DEVELOPMENT REVIEW COMMITTEE

CASE COMMENT REPORT

CASE NO. UDP-S24010

Case Number: UDP-S24010 (SGD Chevron – 1199 S Federal Highway)

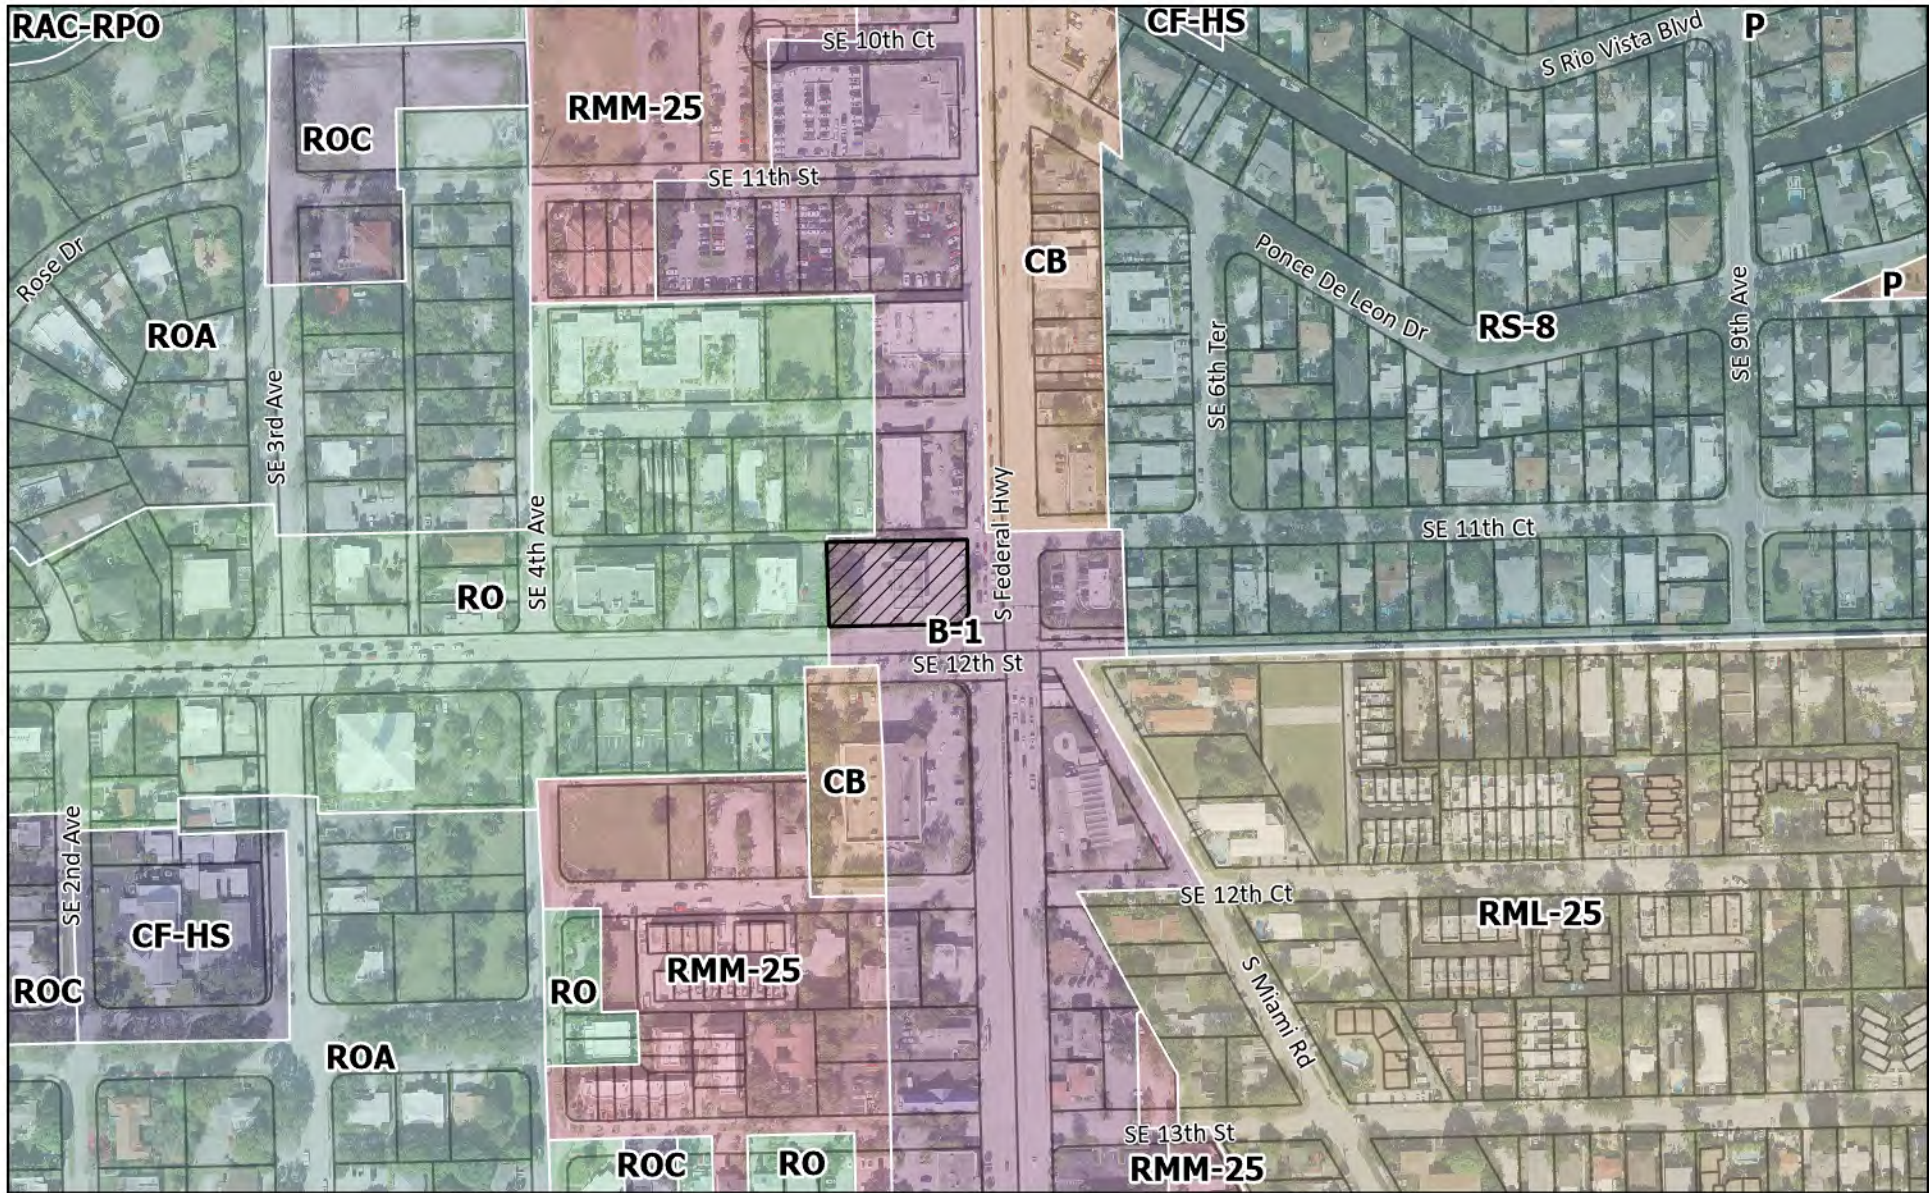
8. Provide the following changes on elevations:
- a. A previous site plan (Case No.: PL-A15010) for a gas station was approved on this site that contain an enhanced architectural design due to the location with unique design features and higher quality materials. The applicant is strongly encouraged to provide a similar building design that has a more compelling street presence, with special attention to the fuel canopy. The City's expectation is that the project will contain the same or similar design. See images below from the previously approved site plan:
